Solo

SOLO EVENTS BOARD | December 1

The Solo Events Board evaluated topics online December 1st. Participating were SEB members Mark Labbancz, Nick Dunlap, Chris DeLay, Doug Rowse, Laurie McCelvey, Rick Myers, John Vitamvas, and Brad Smith. These minutes are presented in topical order rather than the order discussed. Comments regarding items published herein should be directed via the website www.soloeventsboard.com.

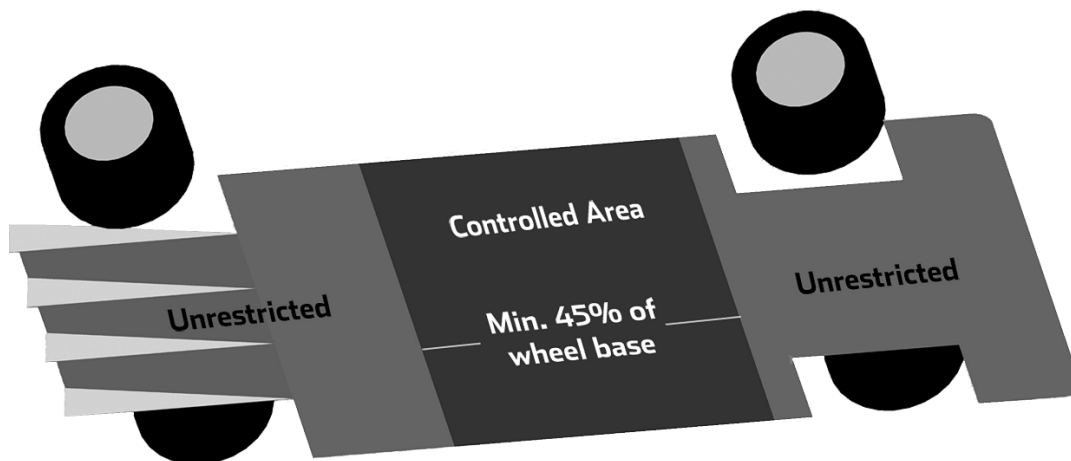
It is the intent of these rules to minimize the use of "ground effects" to achieve aerodynamic downforce on the vehicle. For this purpose, the "Control Area" is defined as the lower surfaces of the body and chassis that are licked by the airstream. This "Control Area" is located within the plan view rectangular area defined by the rear edge of the front tires, the front edge of the rear tires, and the entire width of the car's lower surface facing the ground.

1. The entrant shall designate a flat rectangular reference area with minimum dimensions of 30cm by 60 cm. This reference area is located on the underside of the car (the surface licked by the air stream) between the rear of the front tire and the front of the rear tire. The center of the reference area must be no more than 75mm from the longitudinal centerline of the vehicle. No point or surface on the "Control Area" (as defined above) shall be more than 1" (25.4mm) above or below the plane determined by the above defined reference area designated by the entrant and on a line perpendicular to that reference plane. The total distance between the lowest and the highest point on the defined underside of the car shall also not exceed a maximum of 1" (25.4mm), except as specifically permitted herein. Compliance

with these requirements shall be accomplished by placing a straight edge on the reference surface designated by the entrant and verifying that the requirements are met. A maximum of eight (8) rub blocks of maximum dimension 75mm width by 125mm length are allowed anywhere on the lower surface of the chassis and may extend below the reference plane. Fasteners such as bolt heads and rivets shall not be considered parts of the reference area or the "Control Area". Use of fasteners to circumvent this rule is not allowed. This rule is not to be interpreted as requiring a floor pan beneath the motor, transaxle, transmission or final drive housing.
